A Adaptable units revised based on layout changes. New adaptable layouts proposed. Layouts are supplemented by revised accessibility report from I access

Project
BURWOOD PLACE
42-60 RAILWAY PARADE, BURWOOD NSW
Drawing Title
ADAPTABLE UNITS - TOWER B

TOWER B- POST-ADAPTED RESIDENTIAL LEVEL 3-5, 7-9,
11-3, 15-17 UNIT TYPE 01

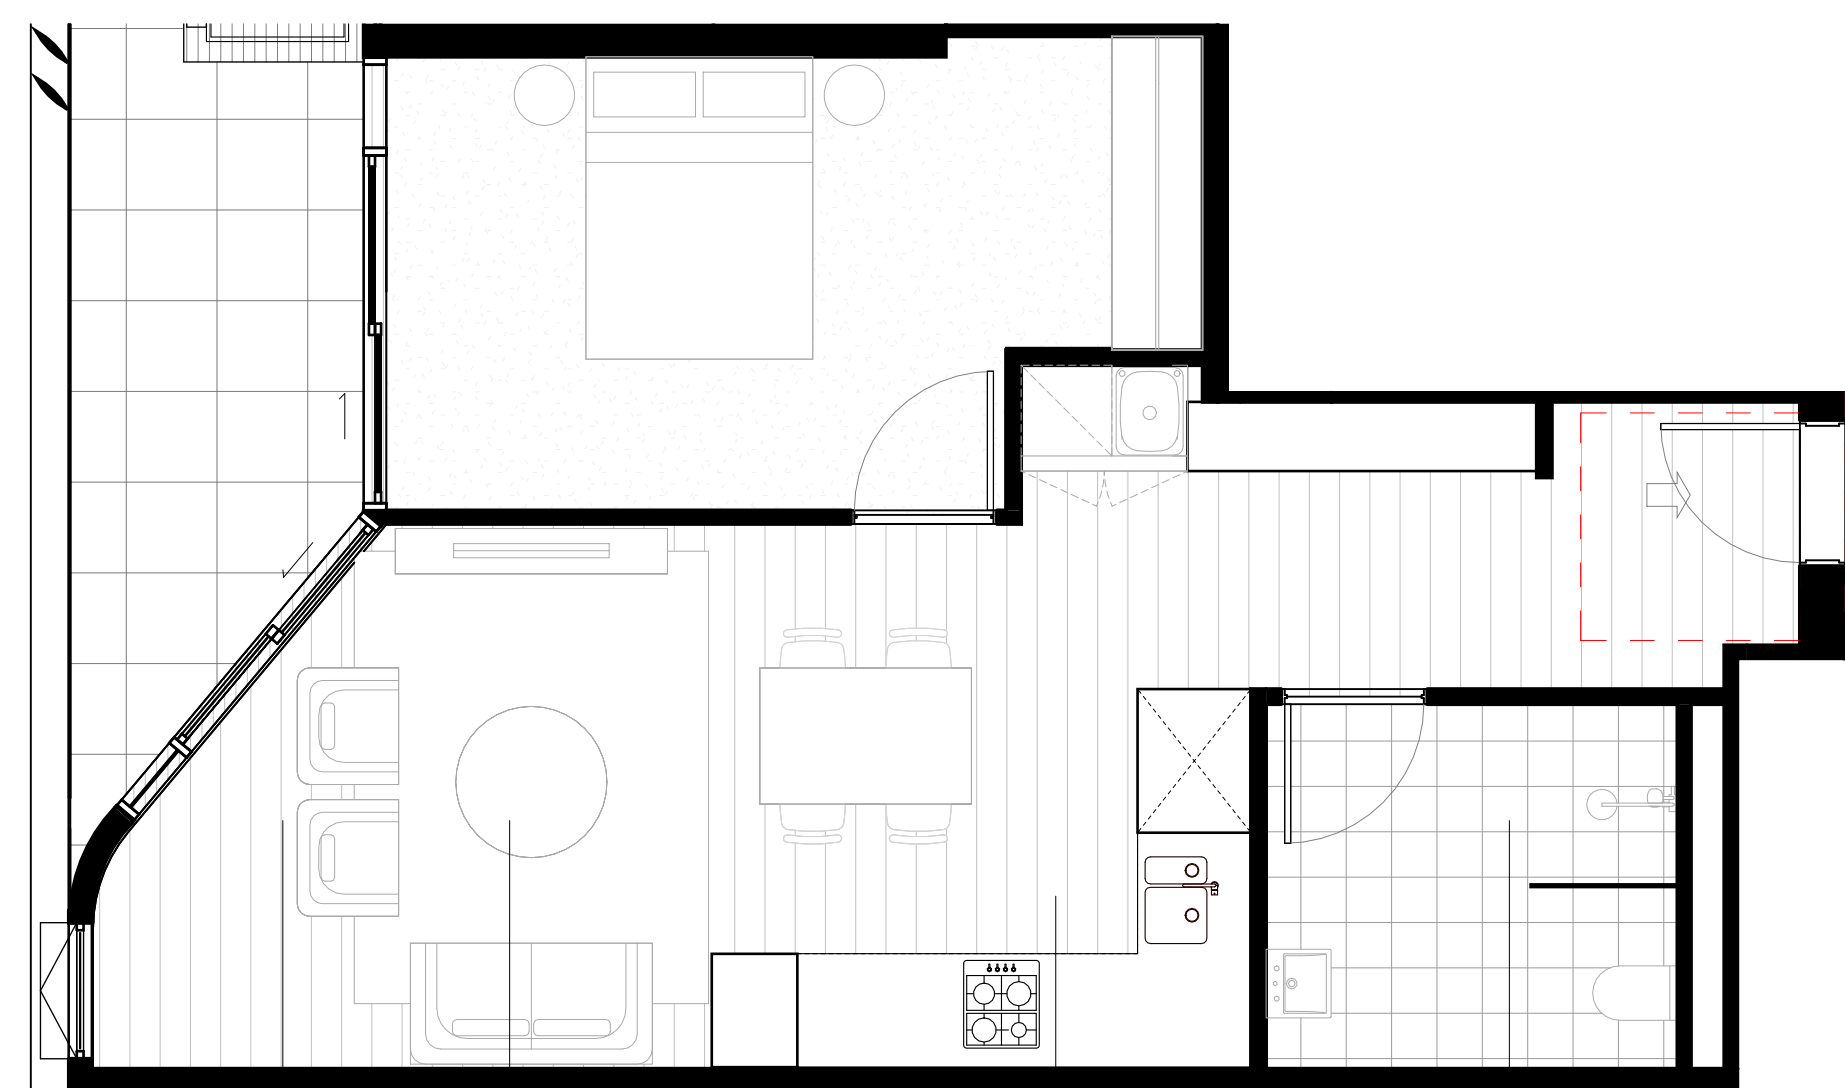
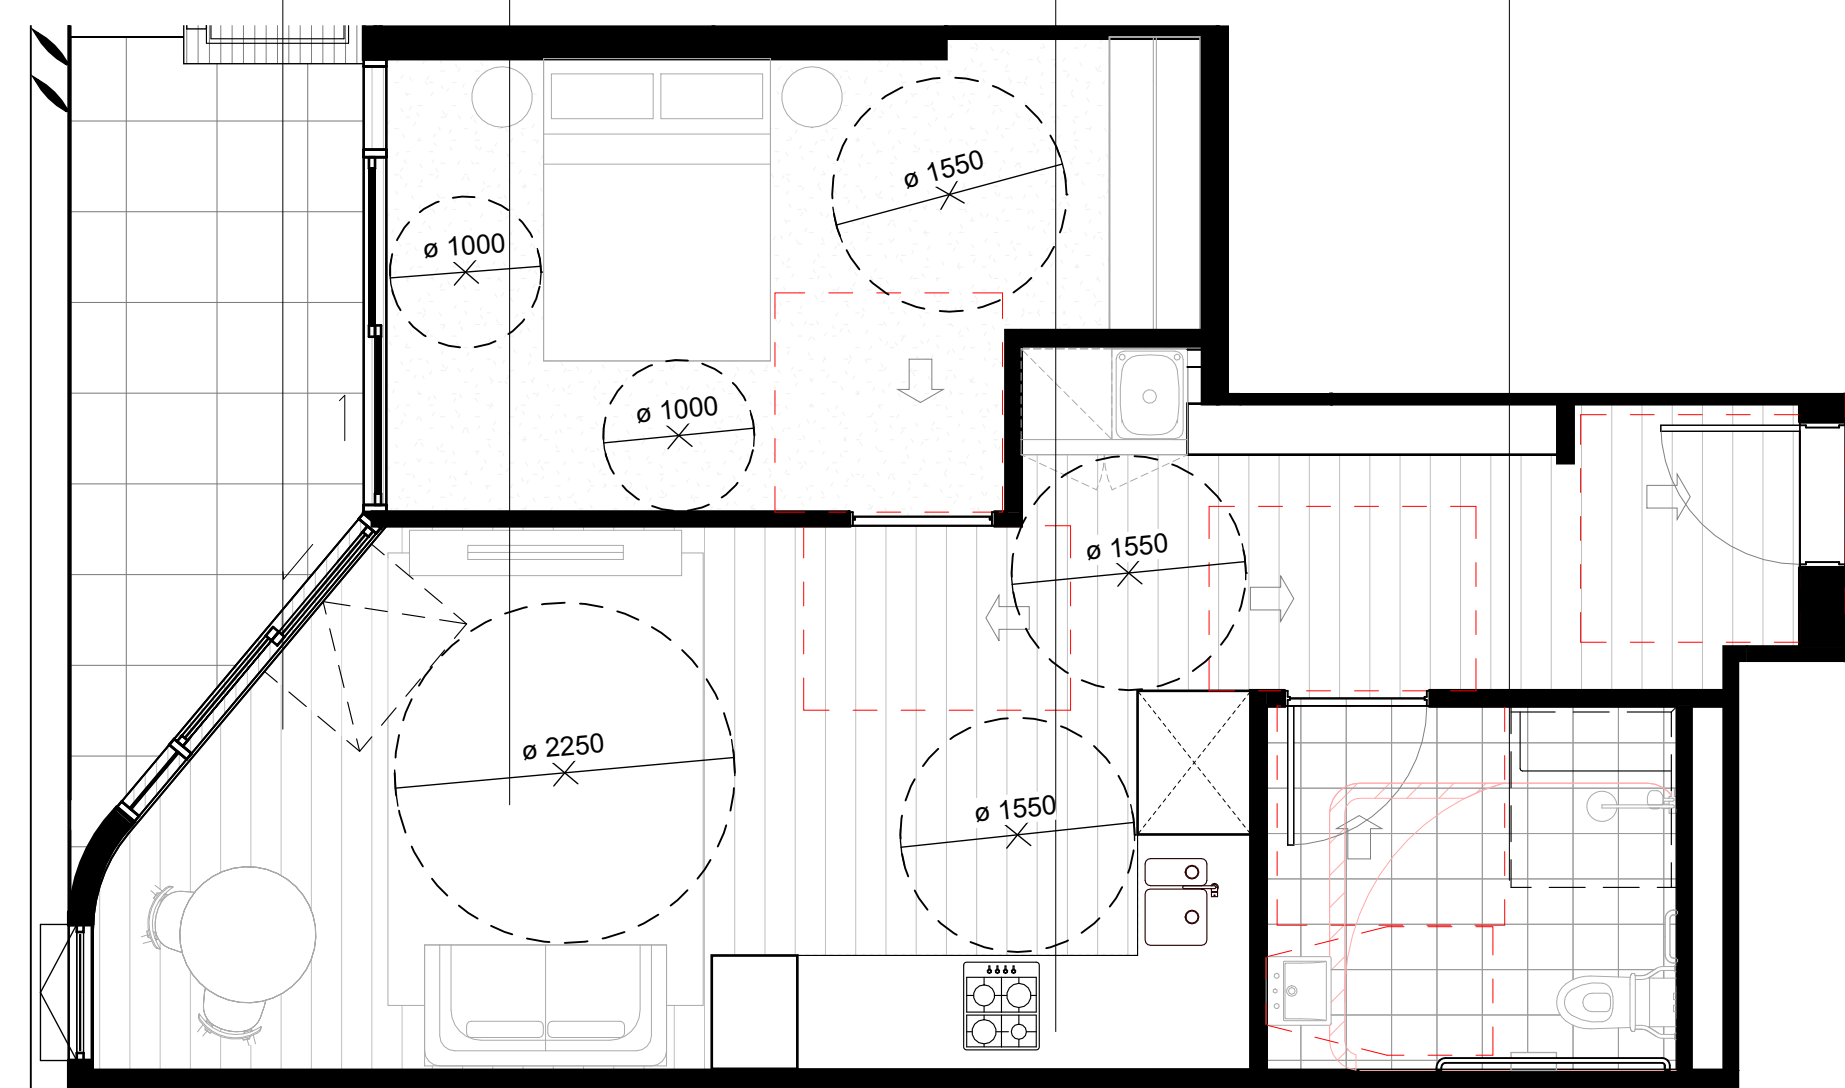
RECONFIGURE
LIVING ROOM
ARRANGEMENT
AND ALLOWANCE
FOR RAMP TO
BALCONY

REMOVE COFFEE
TABLE

RECONFIGURE
KITCHEN TO
COMPLY WITH
AS 4299-1995

REPLACE
SHOWER, WC,
RECONFIGURE
BASIN FIXTURES
TO COMPLY WITH
AS 4299-1995

TOWER B- POST-ADAPTED RESIDENTIAL LEVEL 11-13, 19-21
UNIT TYPE 02

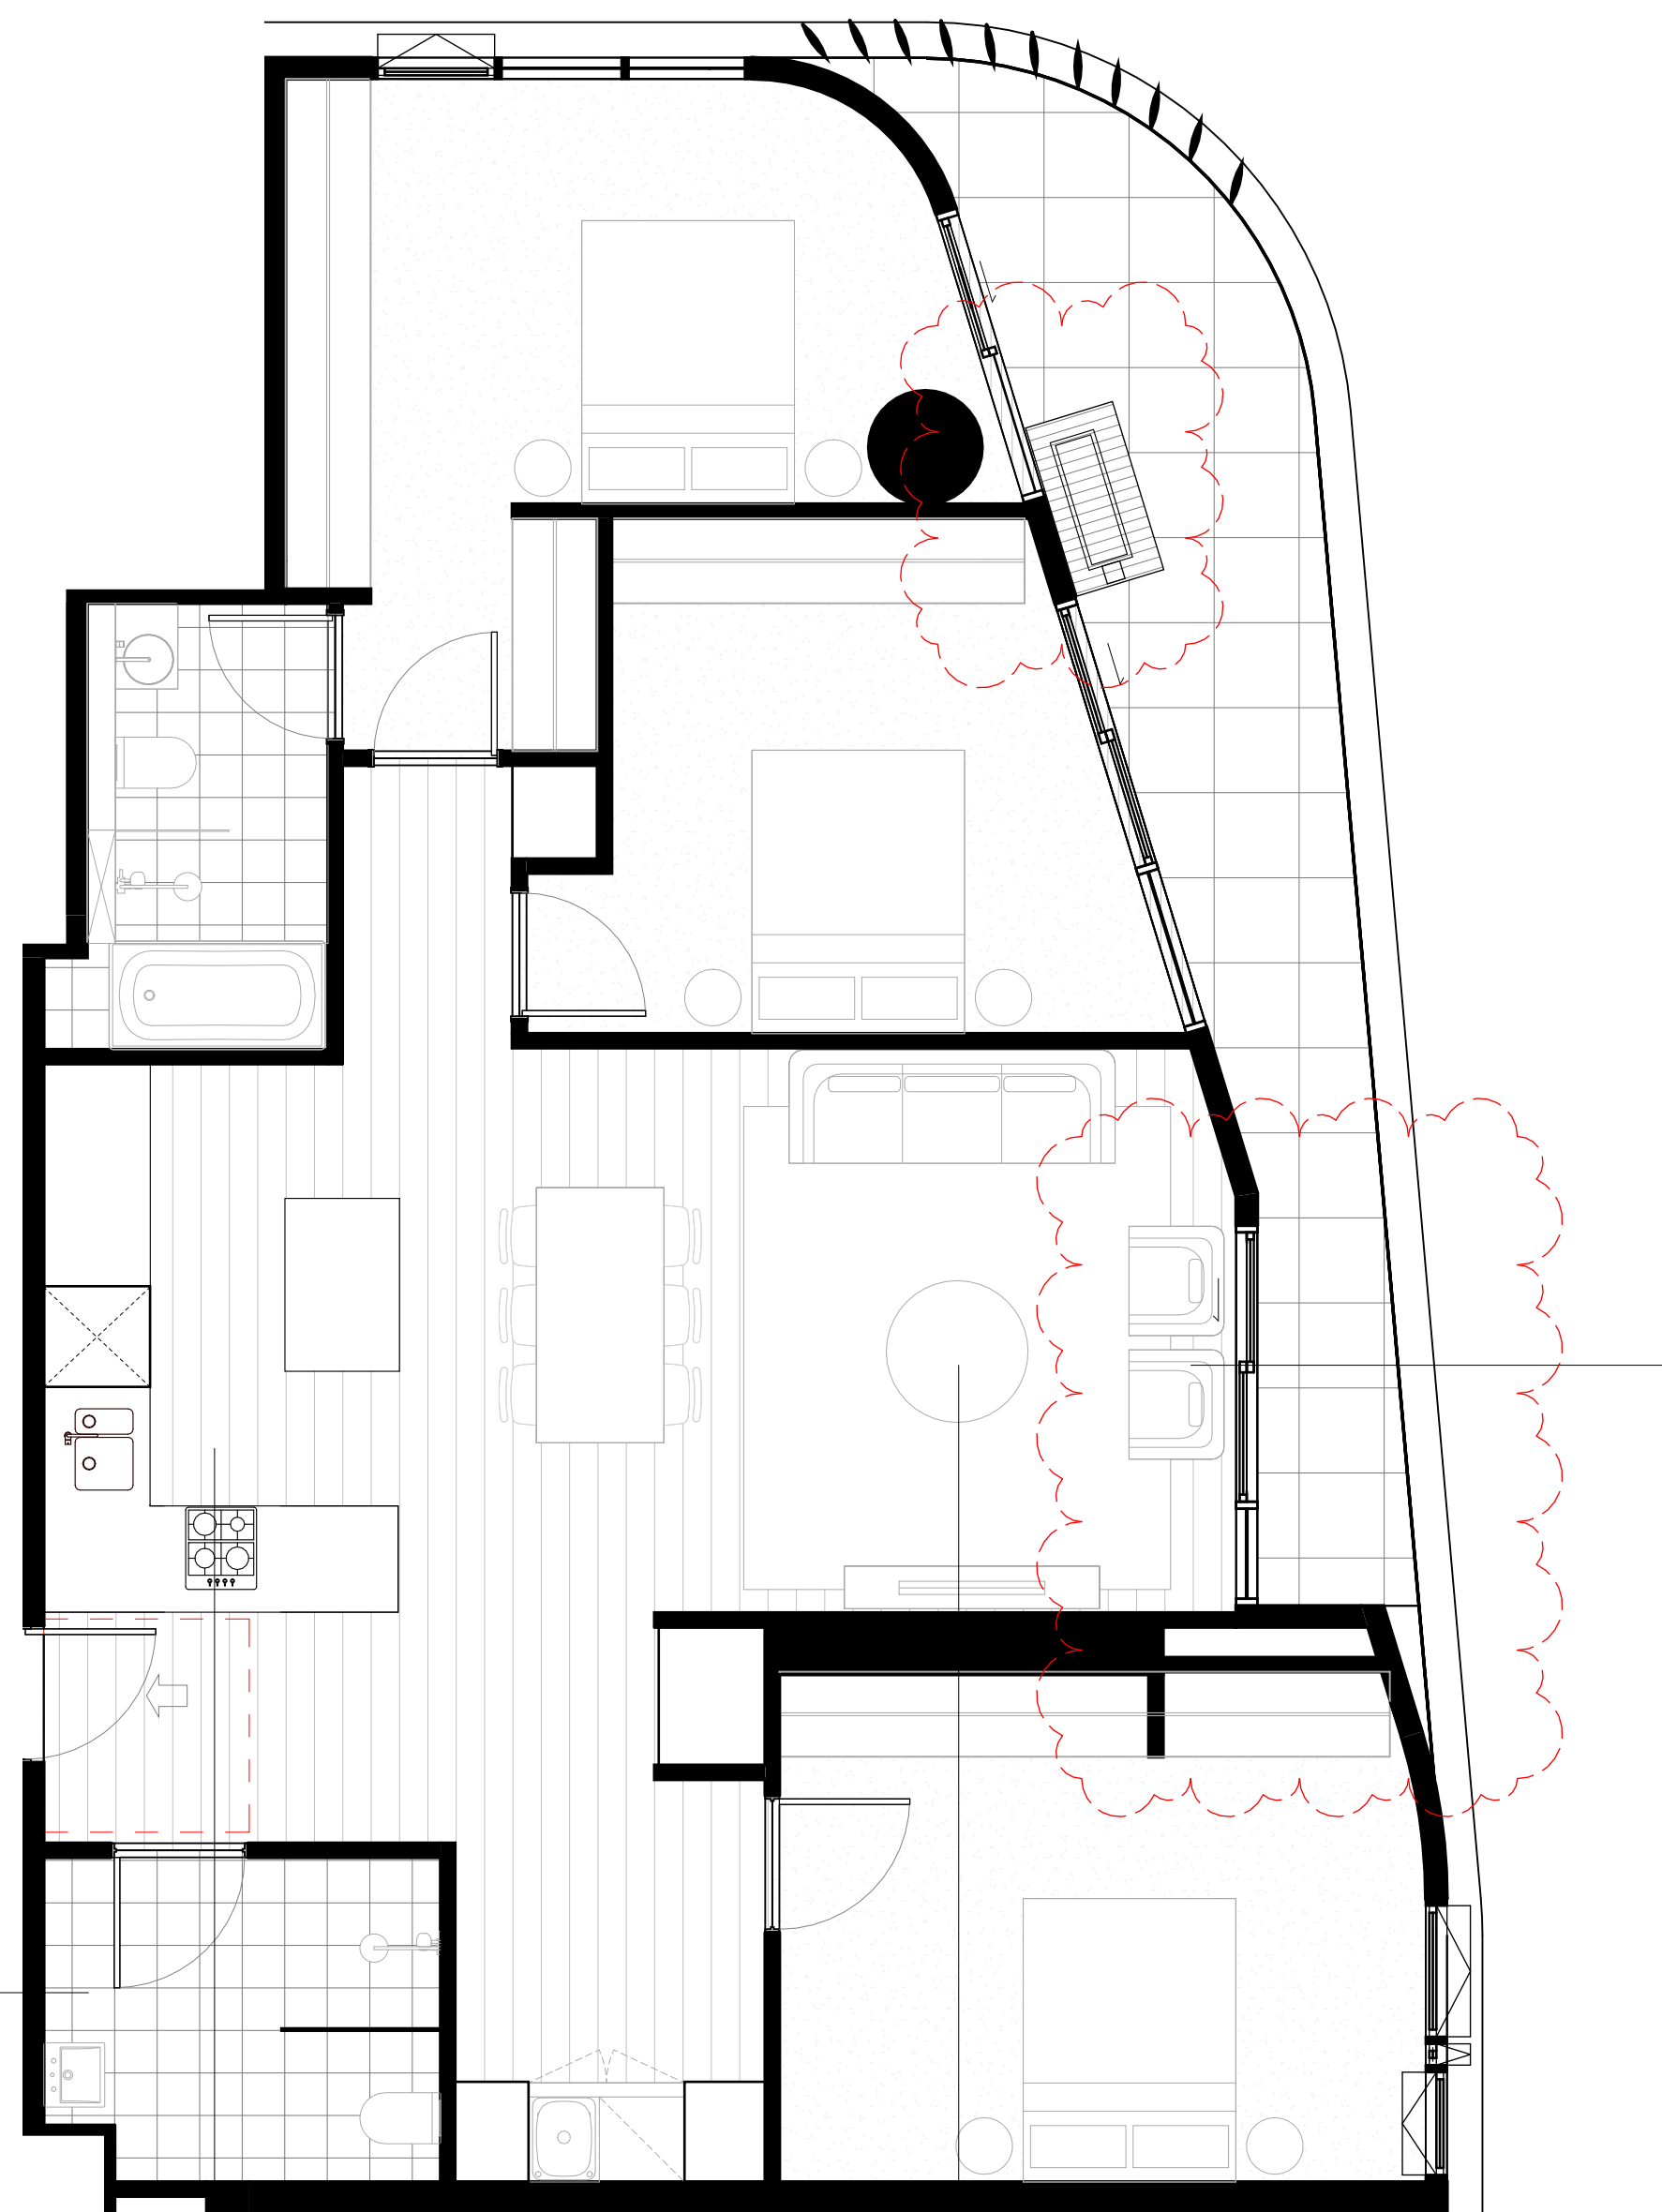
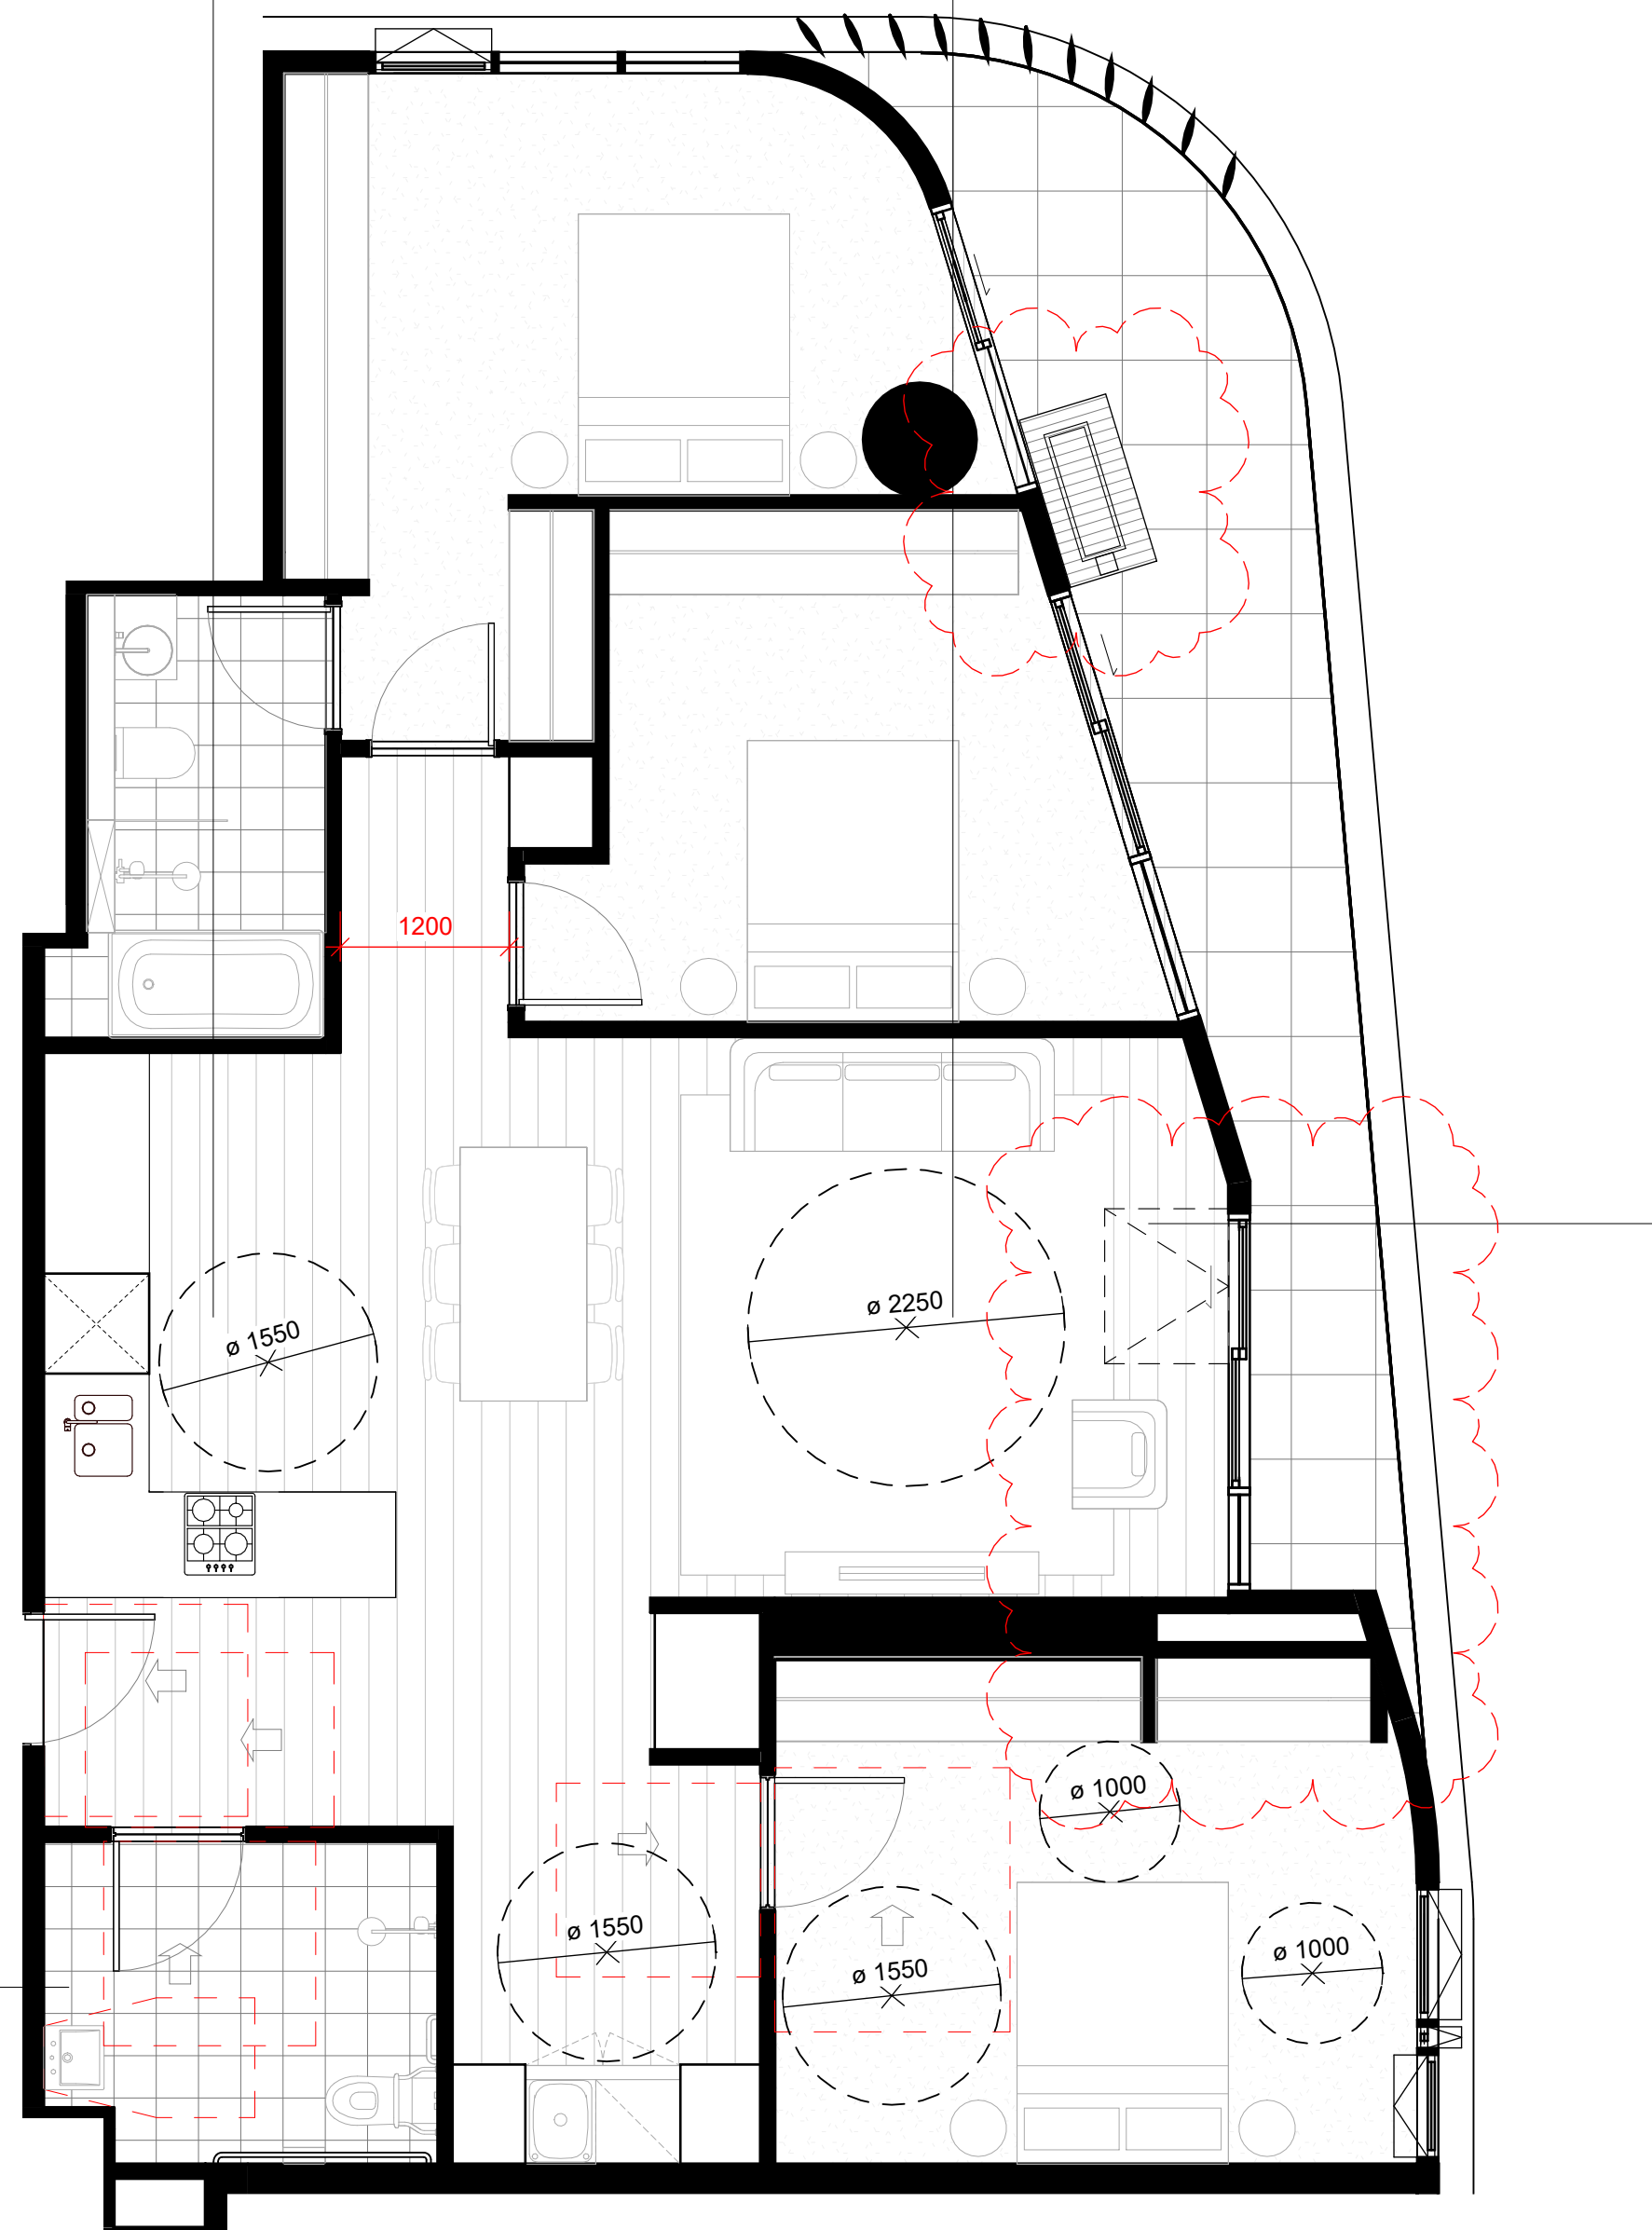
REPLACE
SHOWER, WC,
RECONFIGURE
BASIN FIXTURES
TO COMPLY WITH
AS 4299-1995

RECONFIGURE
KITCHEN TO
COMPLY WITH
AS 4299-1995

REMOVE COFFEE
TABLE

RECONFIGURE
LIVING ROOM
ARRANGEMENT
AND ALLOWANCE
FOR RAMP TO
BALCONY
